REMARKS

"MARK-UP" COPY OF THE AMENDED SPECIFICATION

SCREW WITH A PLURALITY OF HELIX ANGLES AND MOLD DEVICE FOR FORMING THE SAME

Fig. 1

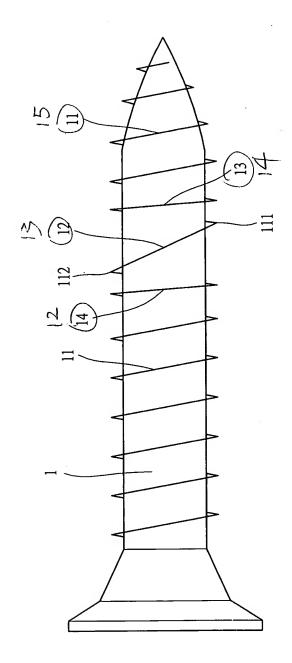
Please amend the drawings 1 to 3 and 11 to 12 as the following. The amendment of the drawings is based on the suggestion of Examiner in the office action. The elements are re-numbered and Figs. 11 and 12 are added the description of prior art. No other portion is amended. Thereby, no new matter is added.
